SERVICE BULLETIN

PURPOSE : CORRECTION	ISSUE NO. : MSB-11E22-502	DATE : 2011-06-20
SUBJECT : TRANSMISSION MODEL		<MODEL> (EUR)
GROUP : MANUAL TRANSMISSION		<M/Y> 11
		i-MiEV (HA3W)

GENERAL INFORMATION

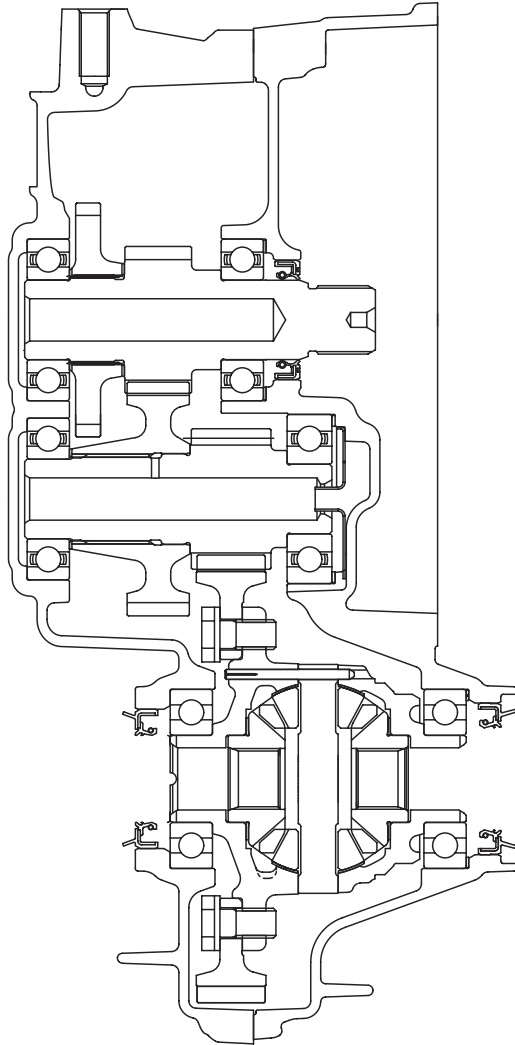
An incorrect transmission model designation has been given in the applicable Workshop Manual. This Service Bulletin contains the corrected description.

Correct: F1E1A-1-A2ZA ← Incorrect: F1E1A-1-A1ZA

F1E1A-1-A2ZA <Correct>
